Report: TAB Report
Function: Test, Adjust, & Balance
Date: 01/06/2026
Completed By: National TAB

PROJECT
03-09-26 QT #1004 CHARLOTTE, NC

Project: 03-09-26 QT #1004 CHARLOTTE, NC

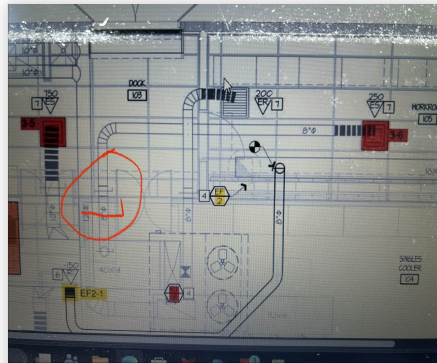
Issue Name : Damper inaccessible RTU 3
Description : Damper inaccessible for SGRD 3-6. Unable to balance diffuser and push the air to the front 4 diffusers.
Created By : National TAB **Assigned To :** National TAB - Dan Hertenstein
Status : Open
Priority : Medium **Asset Tag :** SGRD6
Originated Date : 03/04/2026 - Jearod Ferrette - National TAB
